Soldo Memorial Park at Skye Canyon

Technical Drainage Study Update

Subject: Technical Drainage Study Update for Soldo Memorial Park at Skye Canyon

Purpose: This update letter and plan sheet attachments are provided to support changes made to the storm drain within Alpine Ridge Way for the Soldo Memorial Park at Skye Canyon project. Alignment changes are necessary to accommodate required separation between the proposed 36" RCP storm drain and a water utility that is designed and proposed by others.

Improvement Plan Sheet SD-2

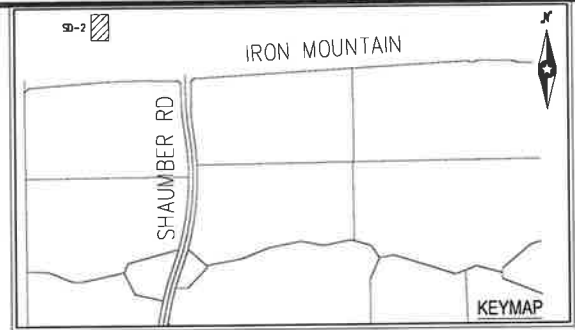
Storm Drain Hydraulics: Due to the conflicting 36" water utility, the proposed 36" storm drain in Alpine Ridge Way was revised to meet UDACS requirements, and therefore proposed SDMH #5 has been shifted northeast to provide required separation. The new proposed storm drain alignment lies between the two previous storm drain alignments presented in the original study's Addendum #2 and Supplement to Addendum #2; the previous alignments can be found in Appendix B. The alignment changes are considered minor, due to the following:

- Slopes for pipe segments between SDMH#4 and SDMH #5, and between SDMH #5 and #6 have remained the same.
- Angle changes at SDMH #4 and #5 are minor and should have a negligible impact on the HGL of the system.

On attached plan sheet 'CEN2201 – Add2 Supp' you can see that when we shifted the 36" storm drain in Alpine Ridge Way to the west, we have insufficient separation between SDMH #5, and a 36" waterline that is being proposed by others. This waterline was not shown on the plans at the time, but its alignment can now be found on attachment 'CEN2201 – pro'. Due to this separation issue, the storm drain has been shifted back to the east some, as well as a slight

angle change out of manhole SDMH #4. These changes allowed for the recommended 10' clearance from the waterline and manhole.

Conclusions: Negligible changes to the system HGL are expected based on these changes, so a new hydraulic model has not been provided. It is expected that the system continues to meet all storm drain criteria, as the HGL for the majority of the system is well under finished grade. The improvement plans included in the last appendix supports the conclusions and recommendations detailed in this Update. If you have any questions or require additional information, please contact us at 702-284-5300.

We are hoping that because this storm drain alignment falls between the previous Addendum #2 Supplement and Addendum #2 alignments, that an update to the drainage study is not required. The angle change is minor, and should have a negligible impact to the HGL which is well under the finished surface.
